CHANGE ORDER
CONSTRUCTION PROJECTS

Contract No.: CC-4508-23/GCM Project Name: LAKE MONROE TRAIL LOOP – PHASE 1 (LAP)

Change Order No.: 04 Work Order No.: (if applicable) _____

ITEM 01 DRAINAGE MODIFICATIONS SANTE FE

Plan & Profile
Celery Ave.

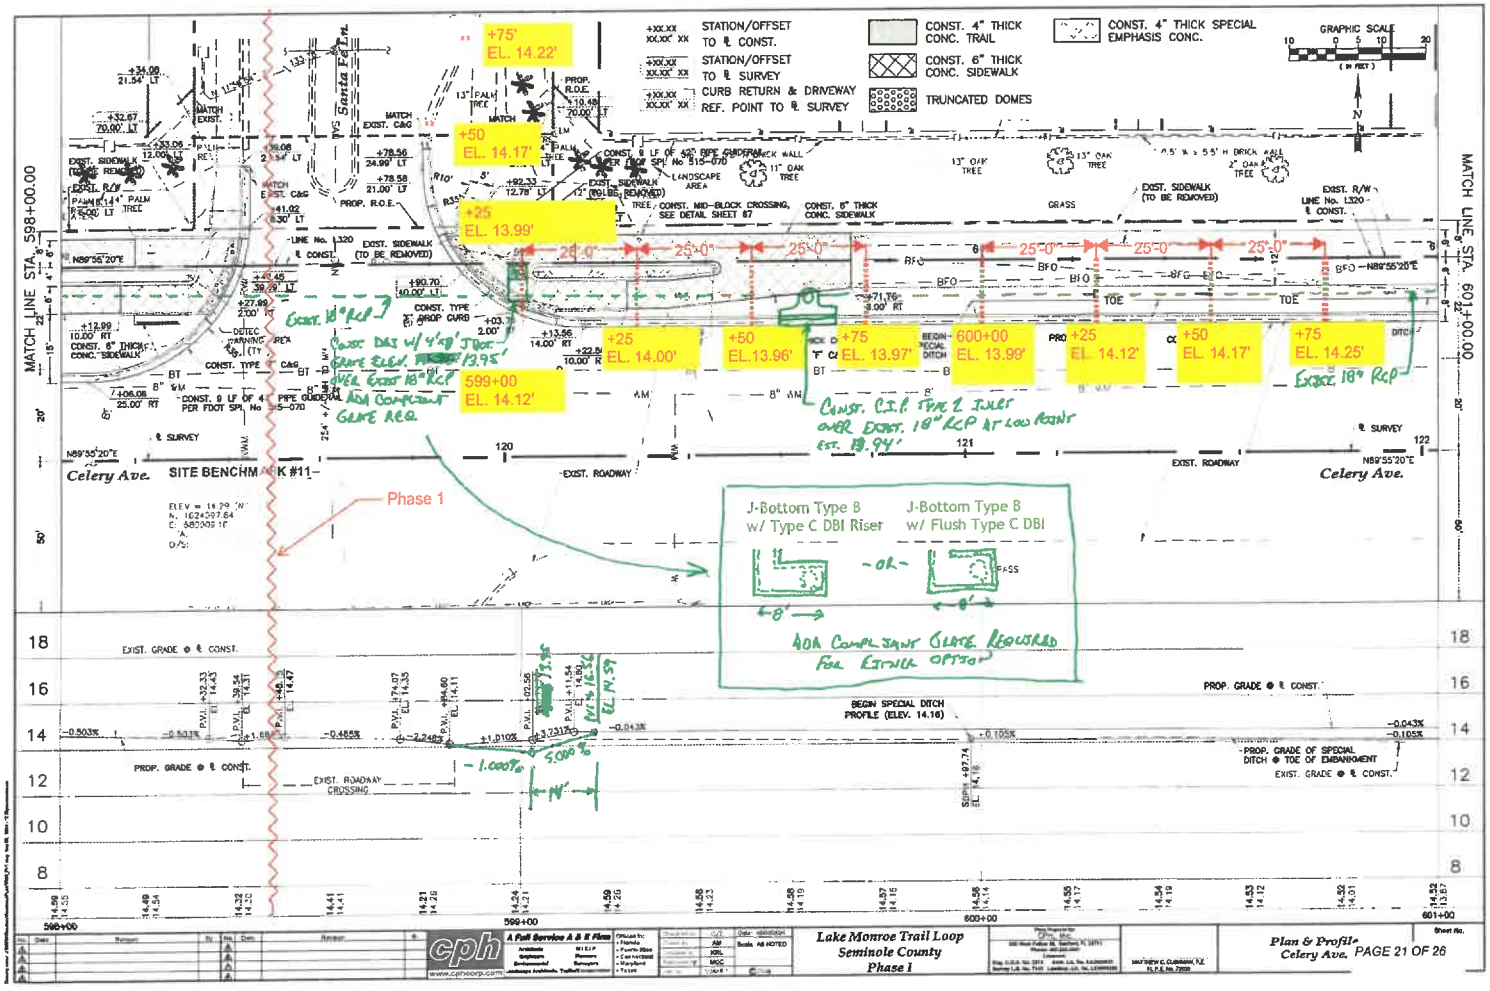
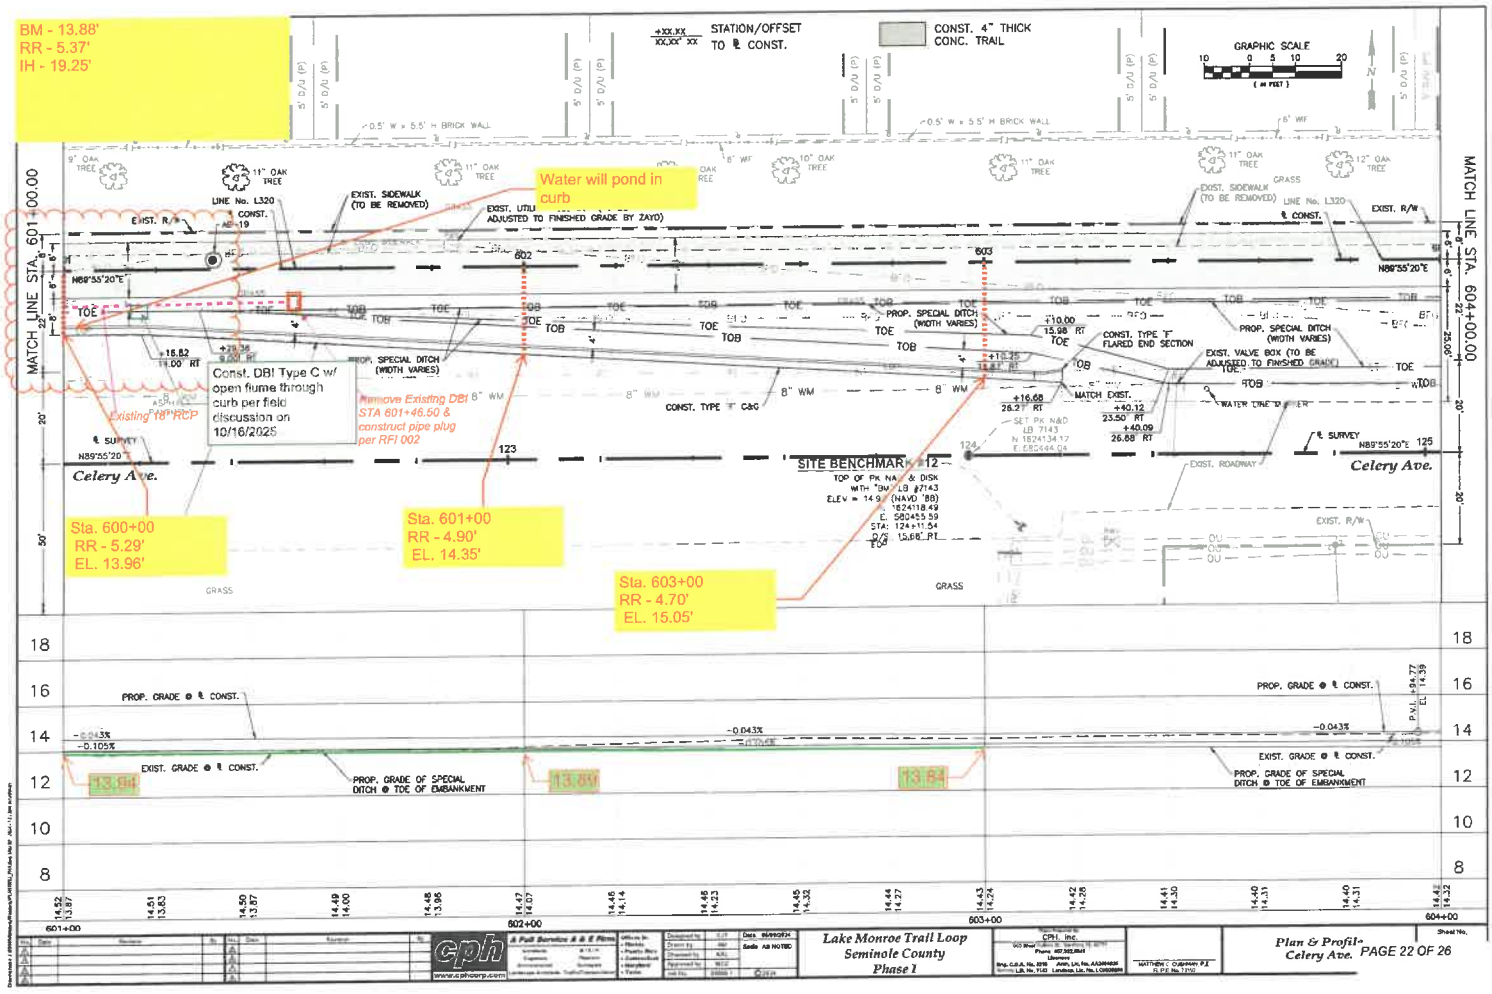
I. Minor Variations Ordered: Per revised response to RFI 007 issued 10/27/25, construct additional ditch bottom inlet integral with trail, additional Type 1 curb inlet, and additional Type C ditch bottom inlet with curb flume, along with associated modification to plan special ditch to accommodate existing field conditions.

Information Requested:
Drainage Concern: The F-Curb between Sta. 598+83.58 to Sta. 603+16.68 is directing surface water flow back towards Sta. 598+83.58. However there is no drainage structure in this area to capture or redirect runoff, resulting in a water accumulation at the Mid-Block location. Please advise how DB Civil should proceed. See the attached plans sheets for field As-built elevations.

Reply:
Revised 10/24/2025
Being previously unaware of RFI 002, and its resolution, I recommend that the Contractor clean out and verify the location of the existing 18" pipe which connects to S-108. If exist. 18" pipe is operational, I recommend the following steps to resolve the ponding concern.

- Construct CIP Type C DBI w/ 4'x8' J Bottom over exist. 18" RCP (per attached drawing) adjacent to the tip of the proposed trail Island. Field modify trail grades to drain to proposed DBI location (including from adjacent roadway (minimal drainage area). Preferred use of Type 8 offset DBI top if clearance over exist. 18" RCP is possible. Alt 7 top acceptable if required.

- Construct curb along turn lane to match exist. grade. Adjust drop curb grade between FOC & BOC as necessary to accommodate positive drainage, not to exceed 5%.

- Construct CIP P-2 inlet over exist. 18" RCP at approx. Sta. 599+65
- Move Beginning of Special Ditch to Sta. 601+30 +/-
- From Sta. 599+00 to 601+25, grade directly from Face of Trail to BOC.

- Construct CIP Type C DBI over exist. 18" RCP at approx. Sta. 601+05 with open flume from curb (or exist. low spot of EOP) as discussed during field review on 10/16/2025

+75'
EL. 14.22'
+50
EL. 14.17'
+25
EL. 13.99'
599+00
EL. 14.12'
+25
EL. 14.00'
+50
EL.13.96'
+75
EL. 13.97'
600+00
EL. 13.99'
+25
EL. 14.12'
+50
EL. 14.17'
+75
EL. 14.25'
Exist. 18" RCP
Const. DBI w/ 4'x8' J-Box Grate Elev. 13.95' over Exist 18" RCP ADA Compliant Grate Req.
Const. C.I.P. Type 2 Inlet over Exist. 18" RCP at low point Est. 13.94'
Exist. 18" RCP
Phase 1
J-Bottom Type B w/ Type C DBI Riser
-or-
J-Bottom Type B w/ Flush Type C DBI
ADA Compliant Grate Required For Either Option
Celery Ave.
SITE BENCHMARK #11
MATCH LINE STA. 598+00.00
MATCH LINE STA. 601+00.00
Lake Monroe Trail Loop
Seminole County
Phase I
Plan & Profile
Celery Ave.
PAGE 21 OF 26
